Sandy Creek Energy Station
Coal Combustion Residual Waste
Management Facility
Registration Application
TCEQ Registration No. CCR107
McLennan County

Technical Notice-of-Deficiency
Response 2

Subject: Sandy Creek Energy Associates, LP – Riesel, McLennan County
CCR Registration No. CCR107
Response to Technical Notice-of-Deficiency 2
Tracking No. 27237612; CN604335455/RN105905657

Sandy Creek Services, LLC, Coal Combustion Residuals Registration No. CCR107
September 22, 2022 Notice-of-Deficiency Response Table

DRAWING TITLE	CROSS SECTION A-A'
PROJECT TITLE	SANDY CREEK ENERGY STATION CCR WASTE MANAGEMENT FACILITY TCEQ REGISTRATION APPLICATION

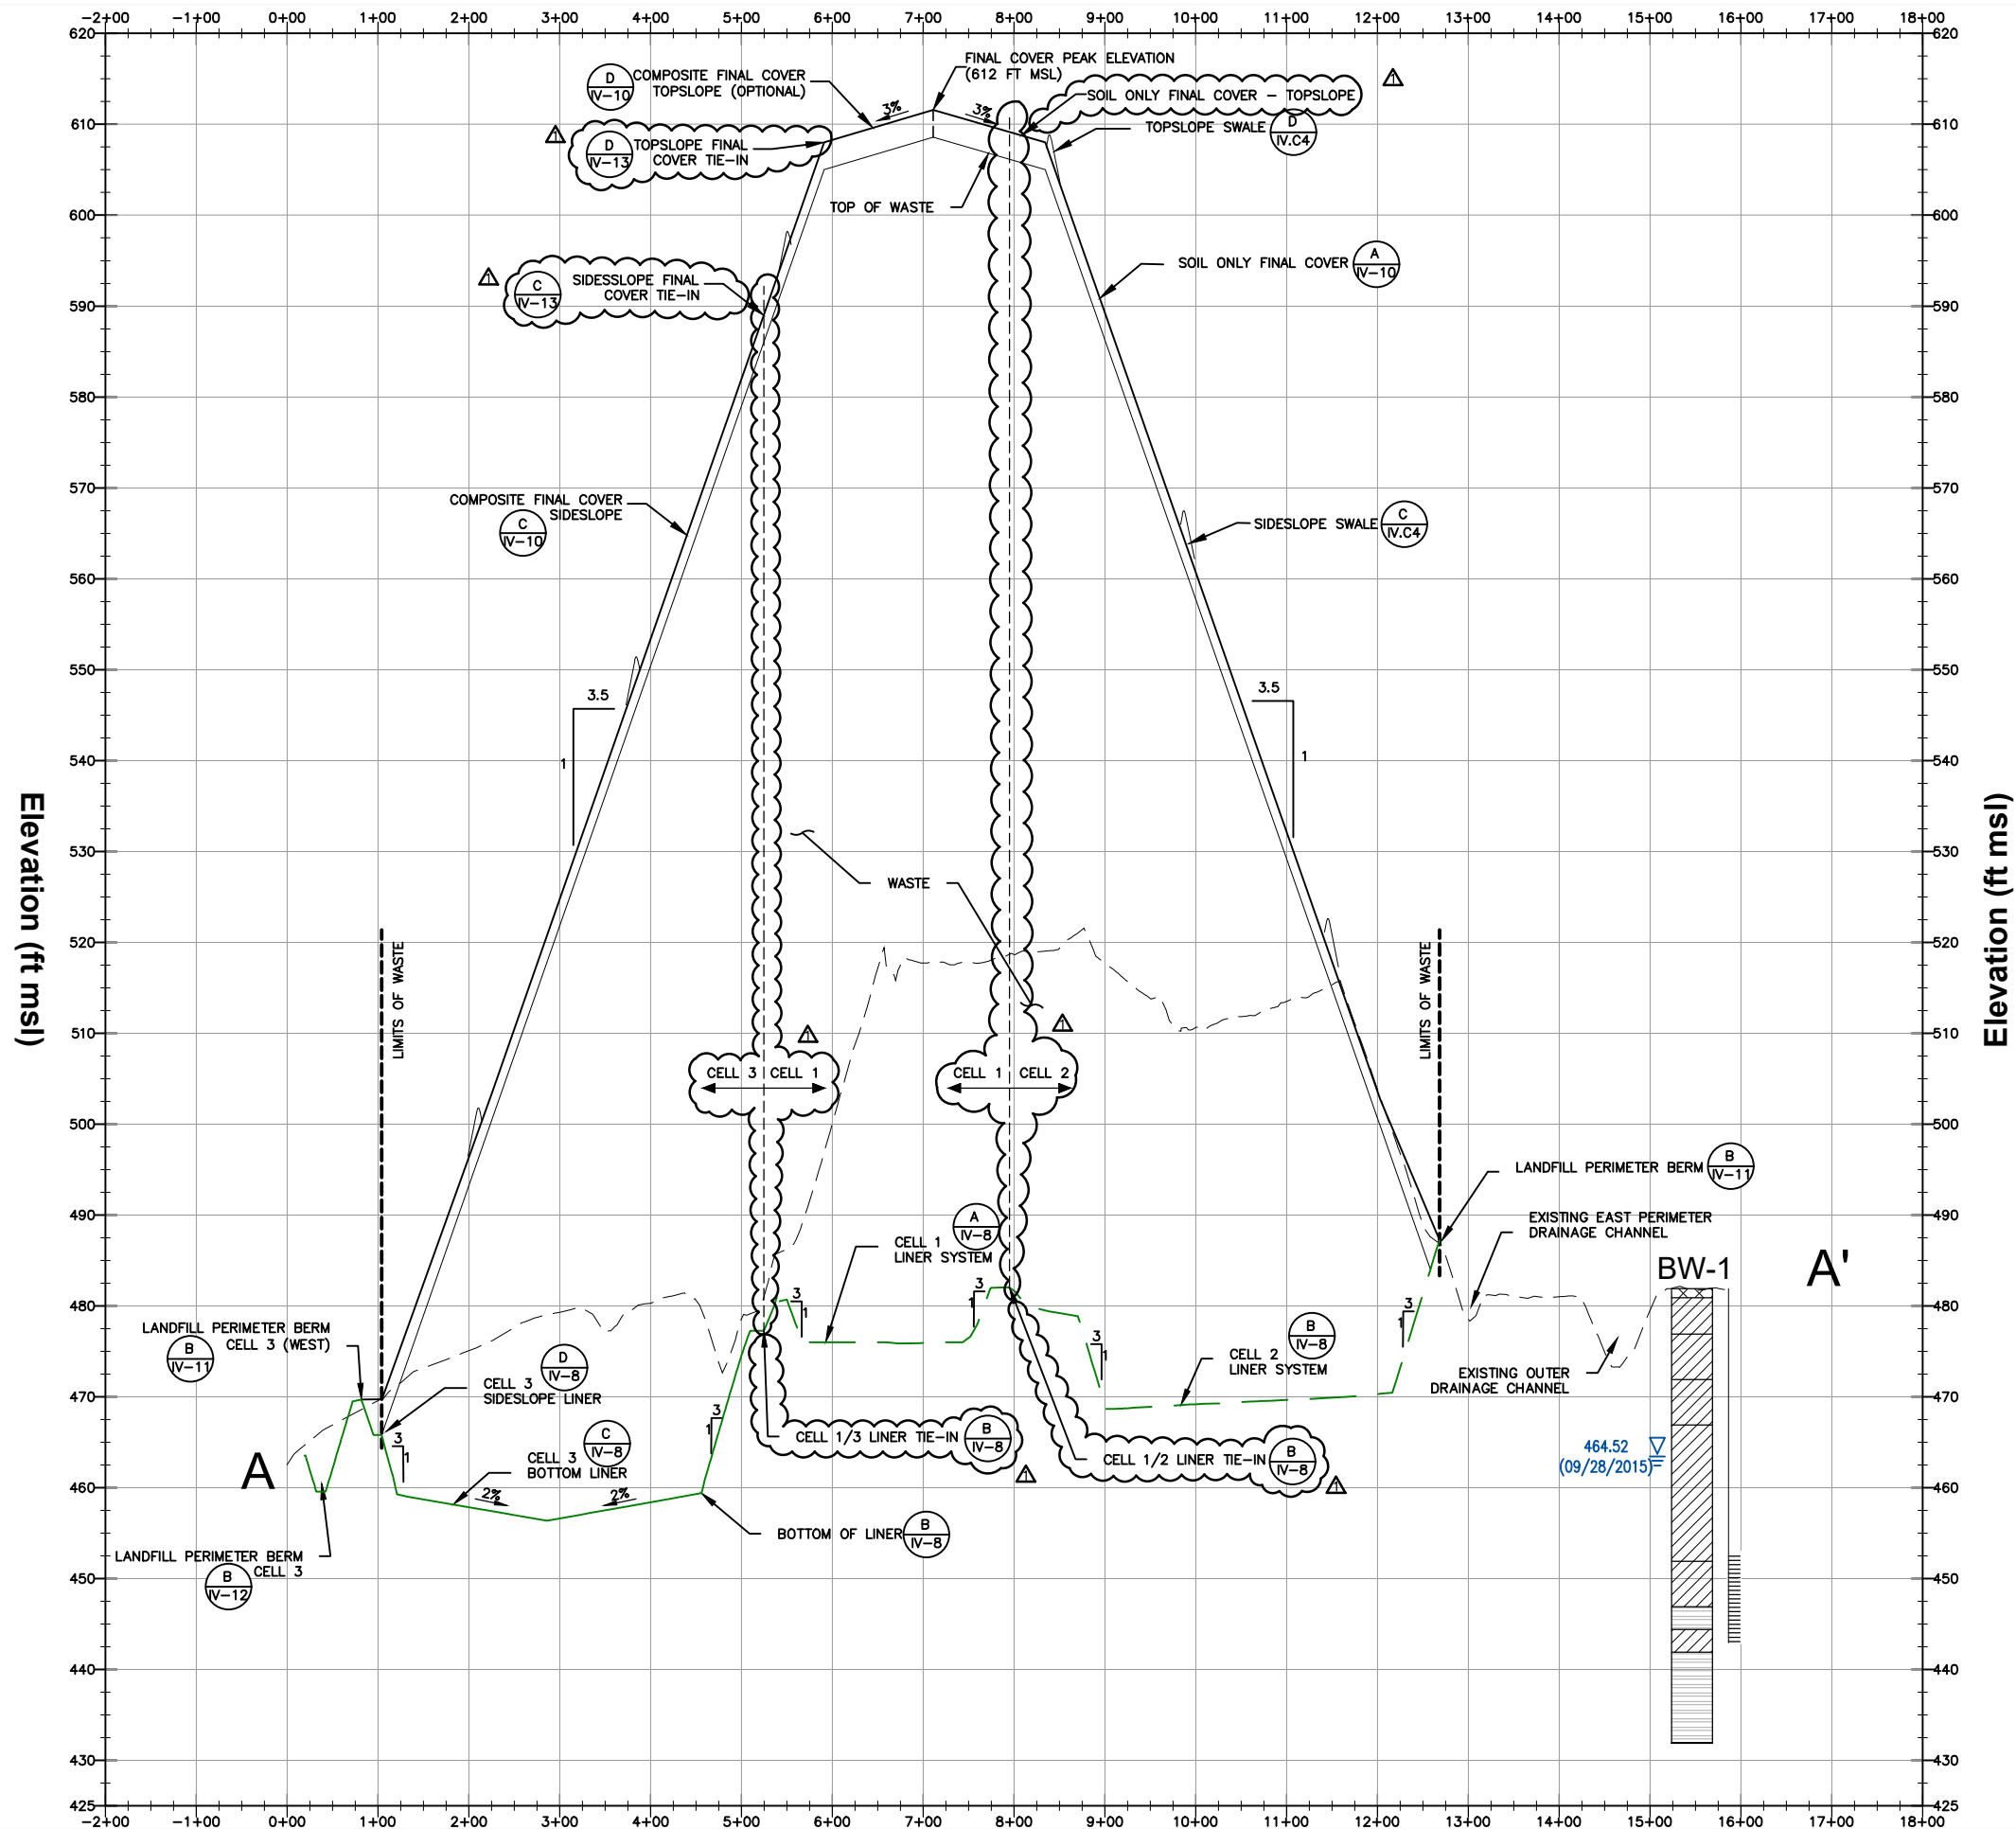
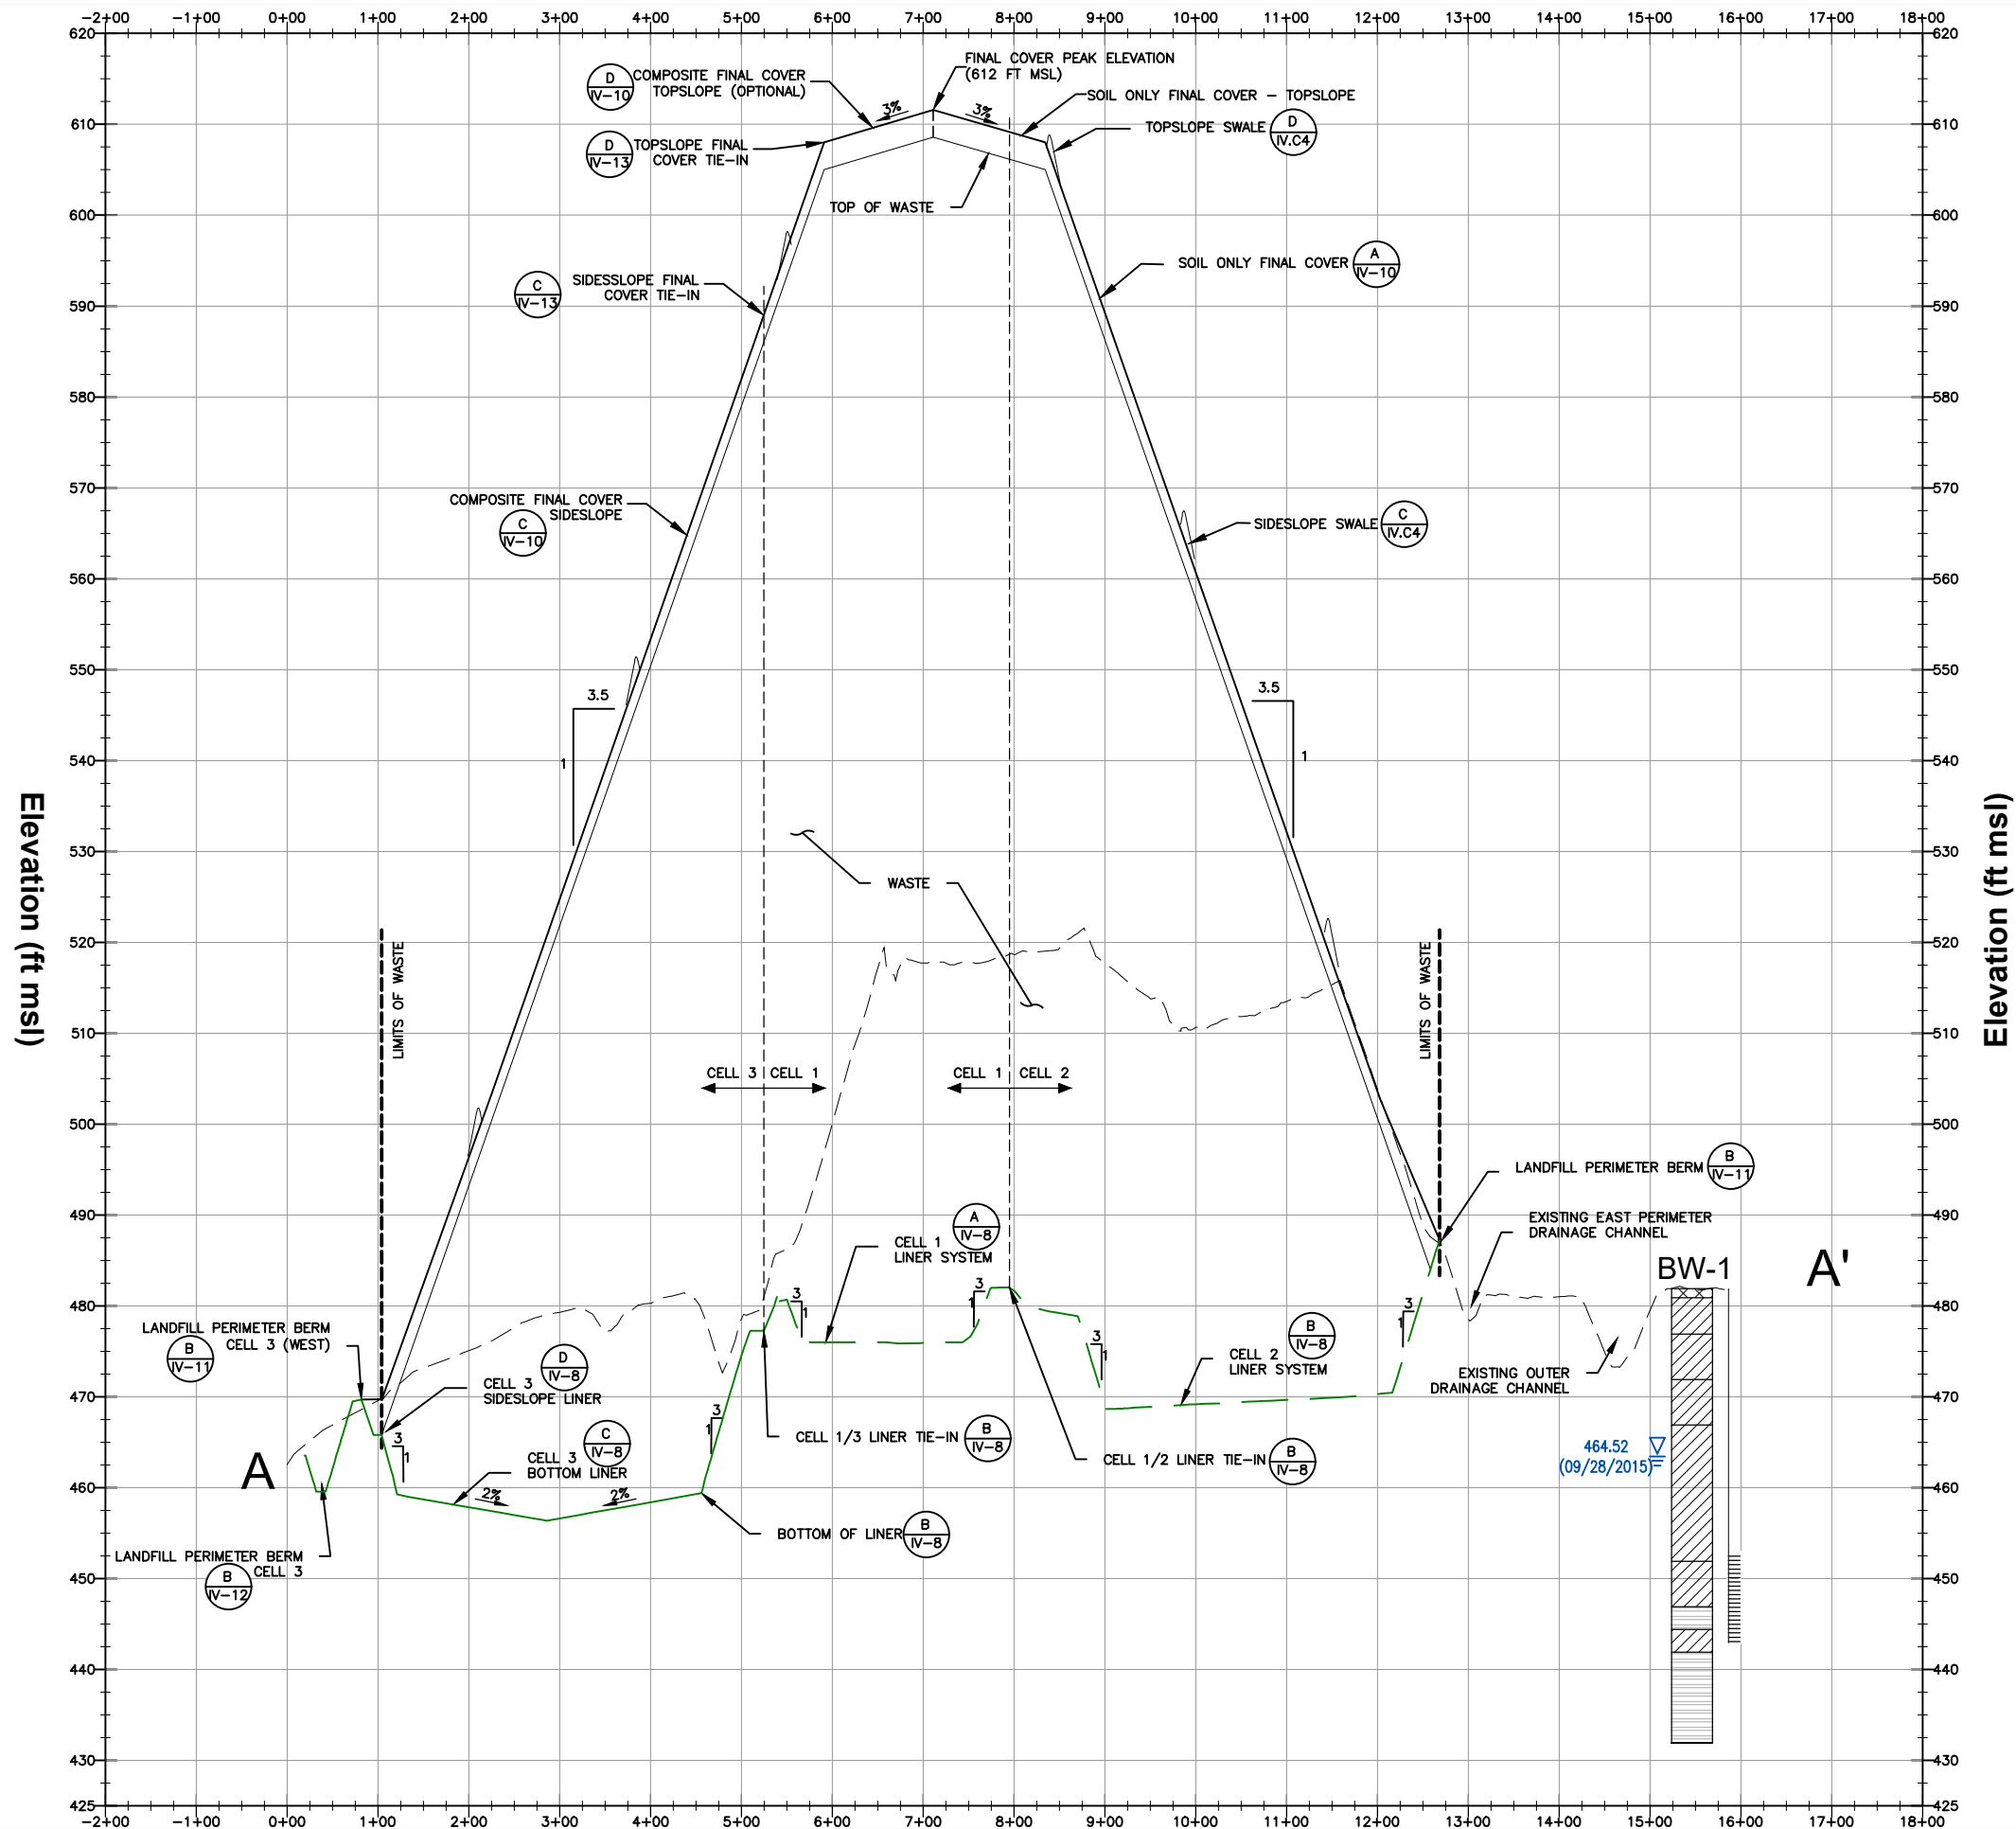
NOD ID	APP. Section	App. Sub Section	Location	Citation	NOD Description	Response
1	IV	IV.25.F	Table IV.D	Application Instructions 40 CFR 257.84(a)(i)	Revise table to indicate that weekly inspection items will be conducted at intervals not exceeding 7 days.	In accordance with 40 CFR 257.84(a)(i)), Table IV.D and Table 3.1 in Part V – Site Operating Plan have been revised to indicate that weekly inspection elements will be inspected at intervals not exceeding seven days.
2	IV	IV.25	[Drawing IV-3]	40 CFR 257.70(d)	Revise Drawing IV-3 to show a Leachate Collection Sump for Cell 2.	Although a callout to indicate the location of the leachate collection sump for Cell 2 was already depicted on Drawing IV-3, this drawing has been revised to further indicate the leachate collection sump location in Cell 2.
3	IV and VII	IV.25 and VII.31	[Drawing IV-10]	40 CFR 257.7	Remove “optional” for Top Slopes (design for Composite Final Cover) and indicate that composite final cover is required for Cell 3.	<p>In accordance with 40 CFR §257.102(d)(3)(I)(A), the permeability of the final cover system must be less than or equal to the permeability of any bottom liner system. Since Cell 3 is the only cell that has a composite liner system, a composite liner system (having permeability less than or equal to the bottom liner system) is only required over Cell 3, as indicated in Note 1 on Drawing IV-10. Since the topslope is not overlying Cell 3 (overlays portions of Cells 1 and 2), composite final cover on the topslope is not required. However, and in accordance with Note 3 on Drawing IV-10, composite final cover may be installed over Cells 1 and 2 (including on the topslope) at the discretion of the Landfill Owner/Operator. Therefore, composite final cover on the topslope is optional and “(Optional)” indicated on Detail D on Drawing IV-10 does not need to be removed.</p> <p>To clarify the locations of soil only and composite final covers, Drawings IV-4, IV-5, and IV-6 have been revised to include cell boundaries. Additionally, callouts and revisions to notes have been made on Drawings IV-4, IV-5, and IV-6 for clarity purposes.</p>

CELL 1/2 LINER TIE-IN (A)
NTS IV-13

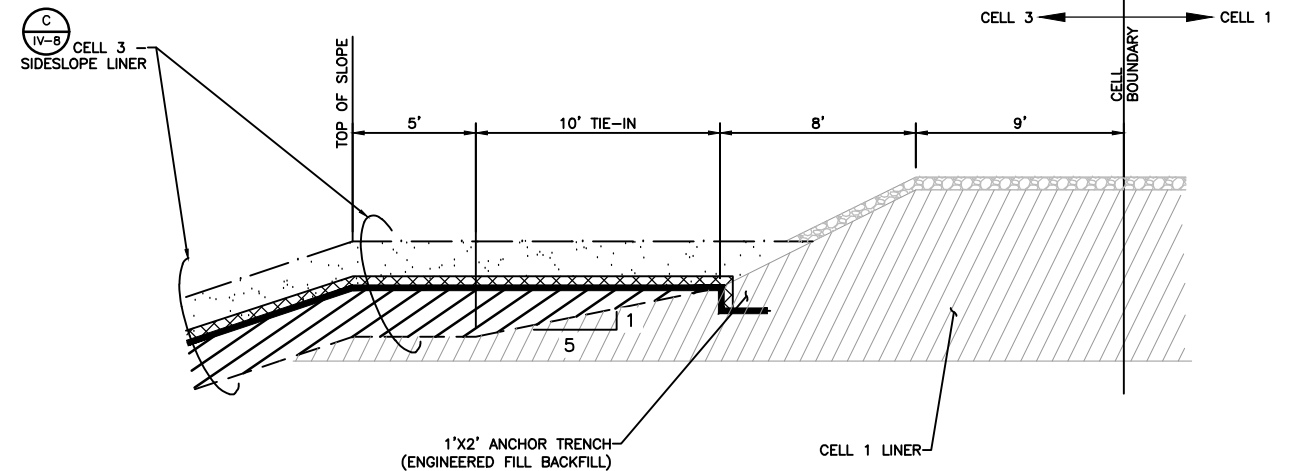
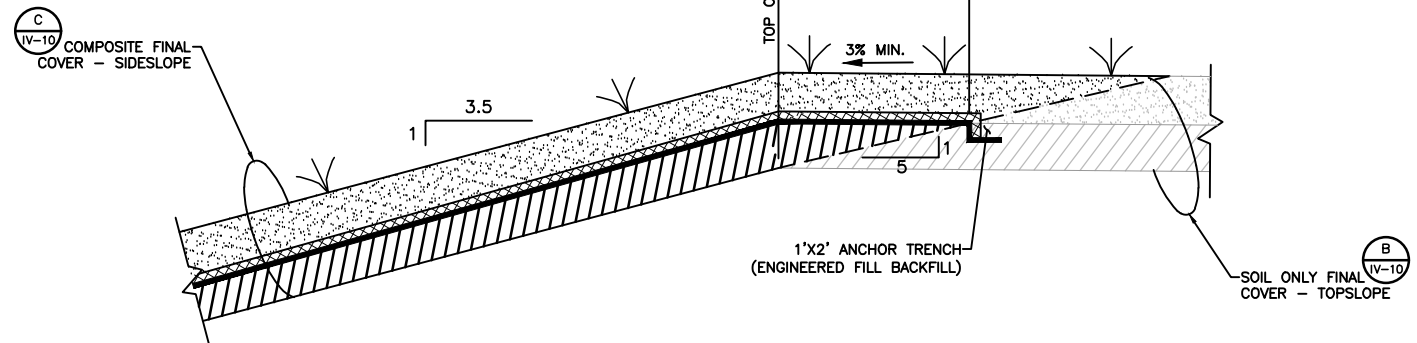
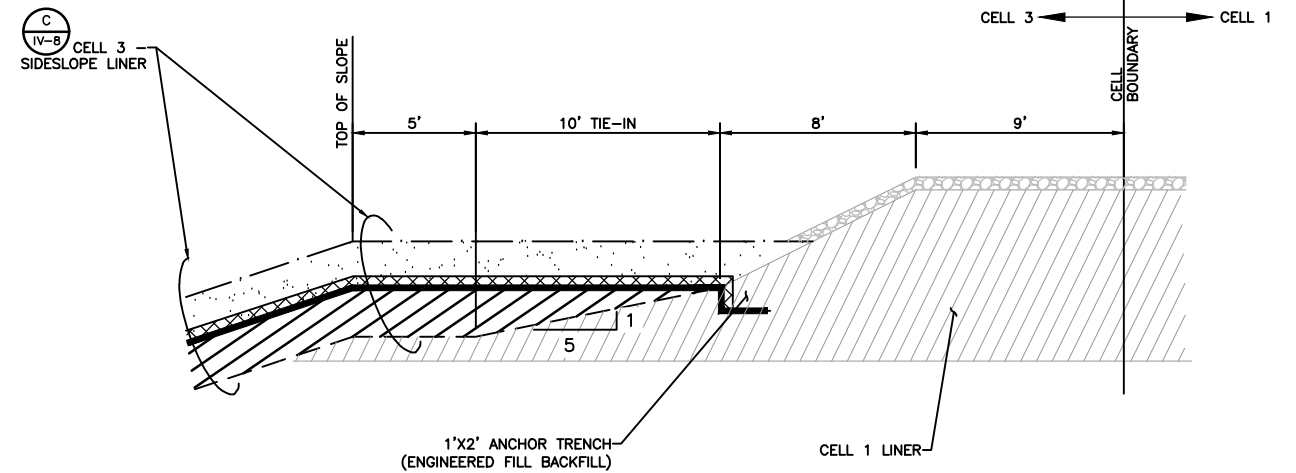
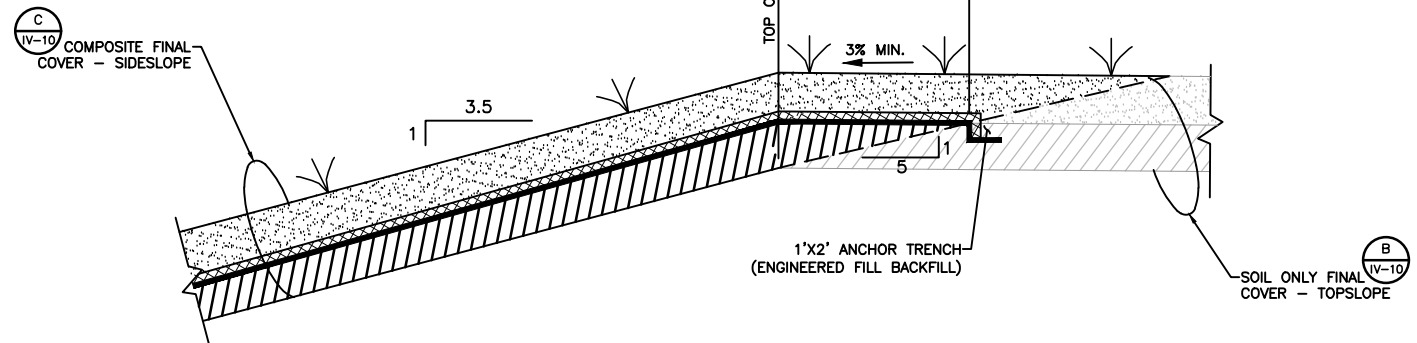
4	IV and VII	IV.25 and VII.31	[Drawings]	40 CFR 257.70 and 257.102 (d)(3)	Provide details and design drawings for the tie-in between the Cell 2 clay-liner system and final cover and the Cell 3 composite liner system and final cover.	In accordance with this NOD comment and the call between Charles Brown and Brett DeVries on September 9, 2022; Drawing IV-13 has been added to provide liner tie-in details between Cells 1/2 and Cells 1/3 (see Details A and B), and final cover tie-in details between the soil only and composite final covers (see Details C and D). Note that since Cell 1 is located between Cells 2 and 3, a Cells 2/3 liner tie-in detail is not required or included. The table of contents for Parts I and IV have also been revised to include the addition of Drawing IV-13.
5	IV	IV.25	[App.IV.A, Subsec. 4.5]	40 CFR 257.70(d)(1)	Provide procedures for ensuring a leachate level of less than 30cm over the liner in the event of a pump failure of more than 24 hours.	As indicated in Section 4.5 of Appendix IV.1 (first paragraph), the Cell 3 leachate collection and removal (LCRS) sump will provide in excess of one-day of leachate storage for the <u>maximum</u> calculated generation rate. Since the maximum leachate generation rate was used for Cell 3 LCRS sump sizing, this calculation does not necessary indicate that the LCRS sump will be full and result in a leachate level greater than 30 centimeters over the liner within 24 hours of pump failure. As a result, Section 4.5 of Appendix IV.A has been revised to indicate that in the event of pump failure, the Landfill Owner/Operator will monitor the liquid level within the sump daily to verify liquid levels less than 30 centimeters above the bottom liner. Additionally, Section 4.5 has been revised to indicate that the Landfill Owner/Operator will have a spare pump and parts onsite or otherwise be capable of pumping liquids from the sump for disposal in the event of pump failure.
